ELM TERRACE

Apartment Renovation and Addition to 68 High Street in Portland, Maine

Issued: November 09, 2011
BOOK 3 – ADDENDA MANUAL

SKS-1-1

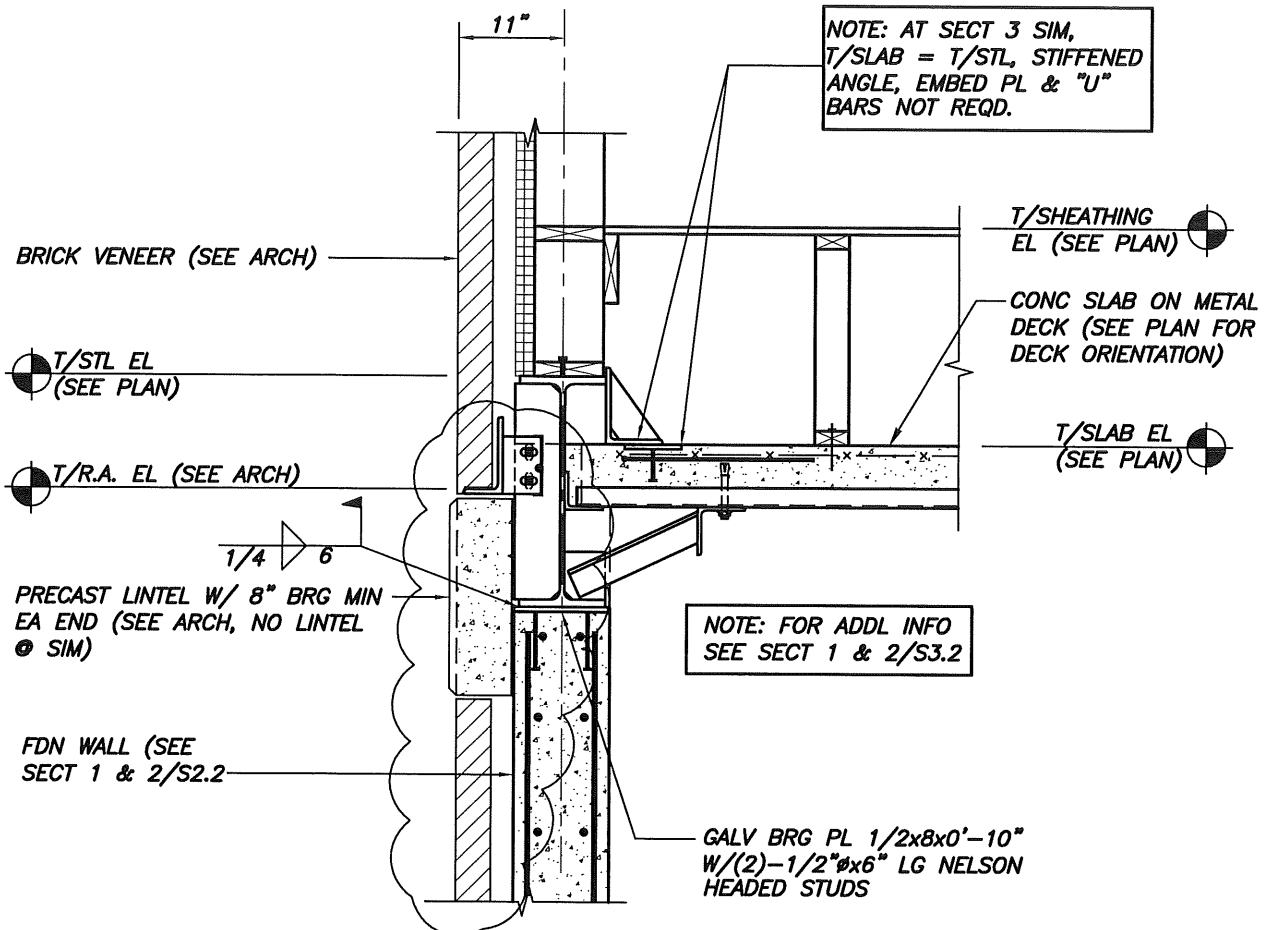
7. Replace detail 2 on Drawing S3.2 with the attached SKS-1-1.
8. Replace detail 3 on Drawing S3.2 with the attached SKS-1-2.
9. Provide square concrete column wraps (not round as indicated on Drawing S1.1) at all six (6) steel columns in the enclosed parking garage area [PARKING GARAGE - 001] per attached SKS-1-3.
10. At all continuous bearing floor trusses to be installed directly over the first floor concrete slab subfloor structure of the building addition wing, a) MSR lumber ratings are not required; and b) the bottom plate of the trusses shall be pressure treated.

NOTE: AT SECT 3 SIM,
T/SLAB = T/STL, STIFFENED
ANGLE, EMBED PL & "U"
BARS NOT REQD.

DRAWING TITLE - UNIT 101 1B-1 ELECT PLAN

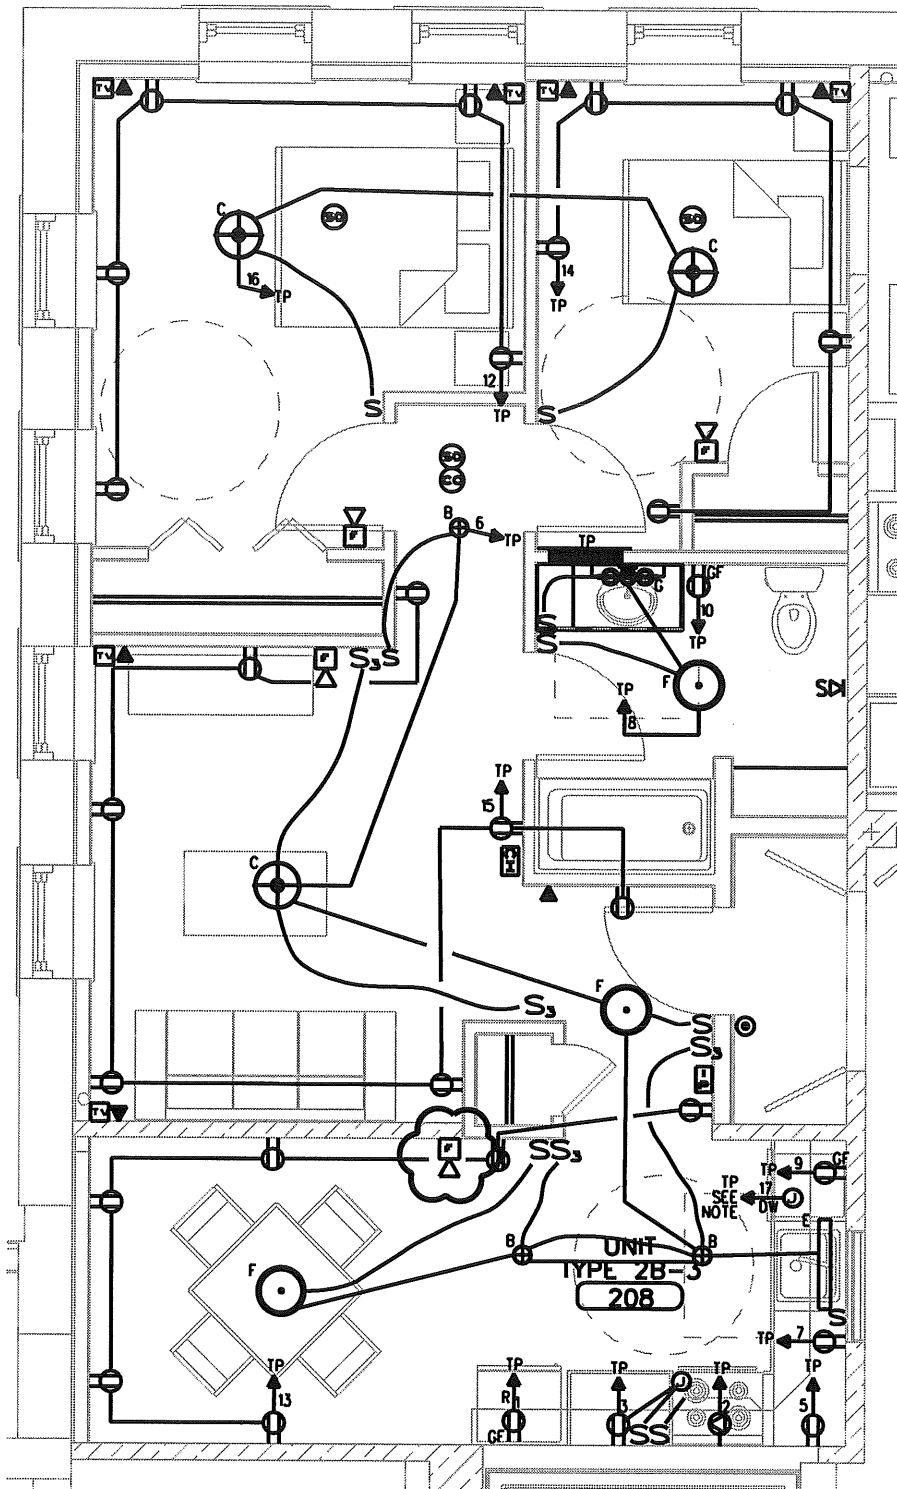
32. Relative to a change in the unit mix that eliminated three (3) three-bedroom units and created three (3) zero-bedroom units plus three (3) one-bedroom units, replace the following drawings with the attached drawings, revised November 8, 2011: **E1.0, E2.1, E2.2, E2.3, E3.0, E3.1, E3.2, E3.3, E3.7, E3.8, E4.0, E4.3**.
33. Provide system connected Fire Alarm notification devices in Units 101 1B-1, 102 2A-HC-1, and 208 2B-3. See attached sketches **SKE-1, SKE-2 and SKE-3**.
